CONDITIONS OF APPROVAL:

Engineering - Final Plat Checklist

Berry Farms Reams-Fleming Tract PUD Sub, final plat - submittal 002.pdf

9. Existing Easements

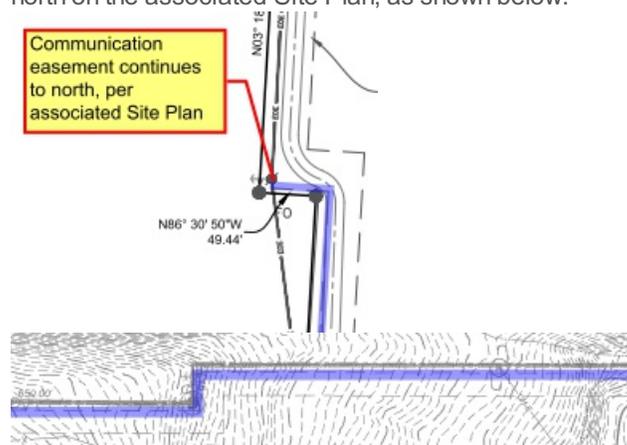
Applicant to clarify the extents of the Communication Easement along I-65. The easement appears to stop on Sheet 4 of 5, whereas the easement continues to the north on the associated Site Plan, as shown below.

## 10. Proposed Easements

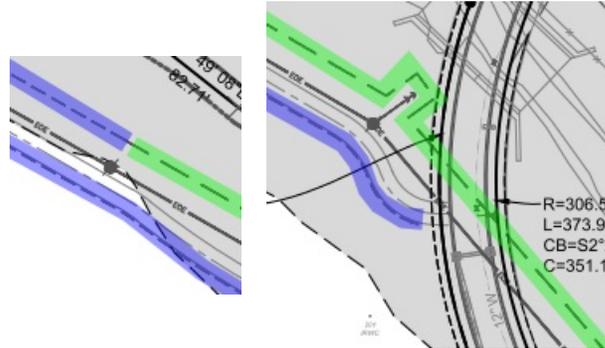
Applicant to label proposed easements, including dimension and type, including the following:

1. Sheets 4-5: Sheets show an assumed utility easement along Five Mile Creek, but it is not labeled or dimensioned, uses multiple line types, and is not a closed shape as some locations show only one side of the easement.

2. Sheets 2-5: Sheets show an assumed utility easement along Peytonsville/Pratt, but it is not labeled, dimensioned, and appears to show only one side of the easement.

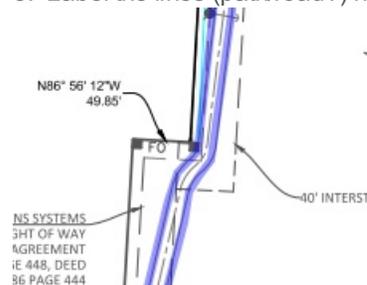
3. Label the lines (path/road?) highlighted below running along I-65 on Sheets 4 and 5.

### 38. Stormwater Features

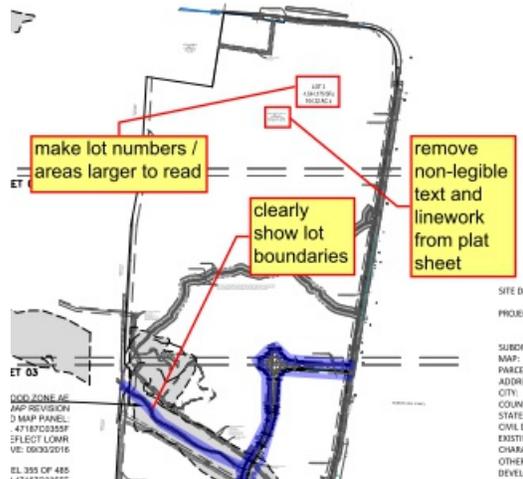
joe.marlo@franklntn.gov Comment partially addressed as Regional Stormwater Areas 2 and 3 are now shown in drainage easements.

All stormwater features receiving flow from multiple lots (such as regional ponds) are to be located in Open Space Lots or are to be within public drainage easements, including Regional Stormwater Area 1 on Sheet 4. Revise linetype of drainage easement for Stormwater Area 1 to match that used for Areas 2 and 3.

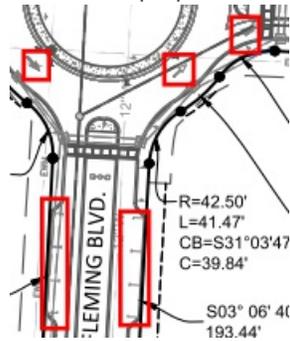
3. Sheets 3-5: Remove fittings associated with wet utilities, as at the scale they are drawn at they can be mistaken for valves.

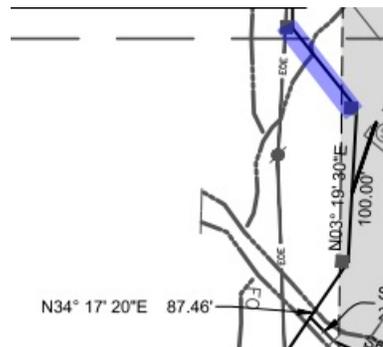
Applicant shall show the lengths of the boundaries of the subdivision, measured to the nearest foot and decimals, with calls, including the line highlighted below from Sheet 4.

43. Plats

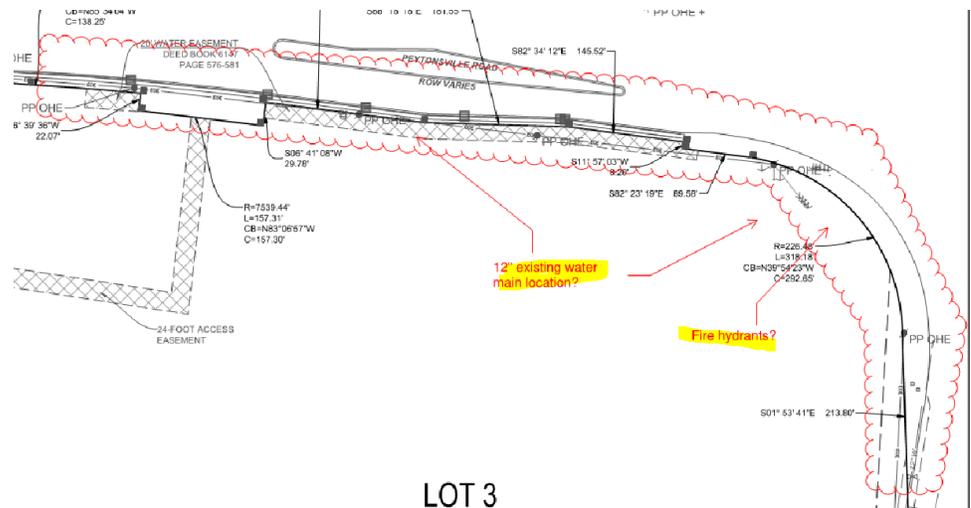
jeff.willoughby@franklintn.gov Riparian buffers shall be shown on Five Mile Creek

22. Reclaim Water

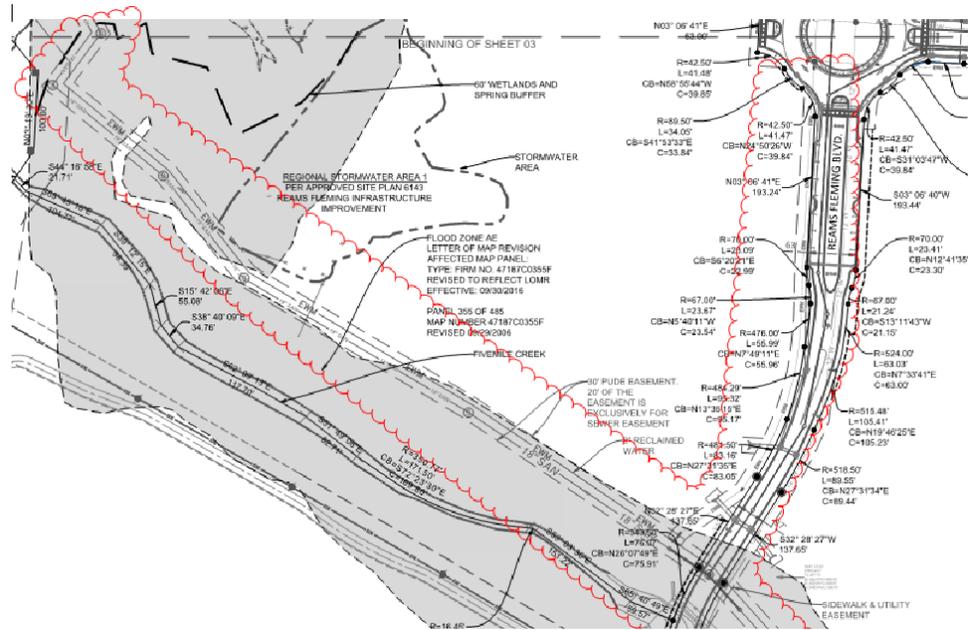
ben.mcneil@franklintn.gov Applicant failed to address the issue, applicant shall show the reclaim water line labeled as RW. the reclaimed water line shall have the minimum 20' easement shown and be labeled as exclusive. The easement shall run the entire length of reclaim water line.

**25. Utility easement**

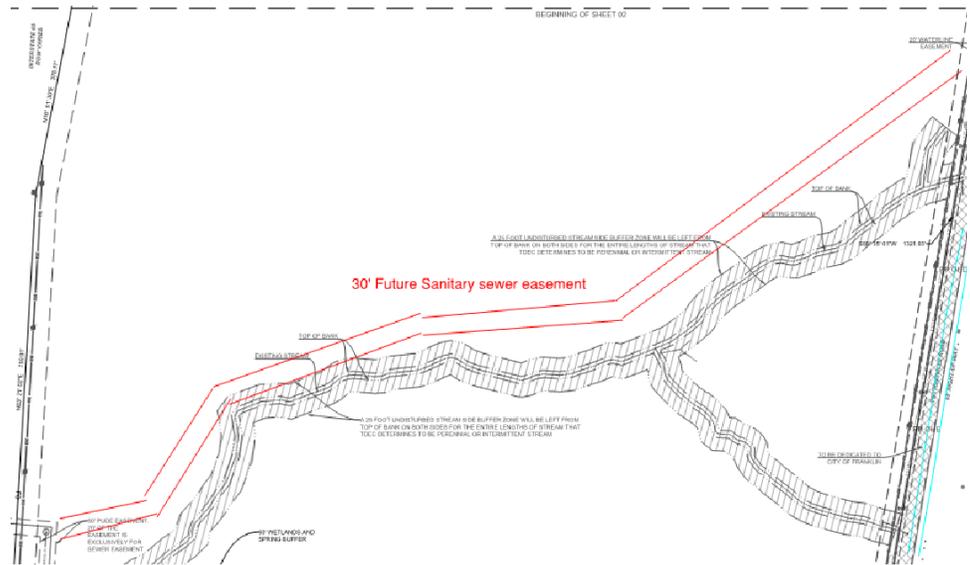
ben.mcneil@franklintn.gov Applicant did not fully address the issue, all Franklin utility easements are to be labeled as exclusive. Applicant shall revise the utility easement to be exclusive.

A. Water, Wastewater and/or Reclaimed Water Mains: When required, permanent exclusive easements must be provided with a minimum width of 20 feet. Easement width requirements are as follow:

1. 0'-12' depth requires 20' easement.
2. 13'-20' depth requires 30' easement.
3. Depths greater than 20' requires prior approval.

A minimum 10-foot wide temporary construction easement on each side of the permanent easement must also be provided. No trees shall be planted within the permanent easements.
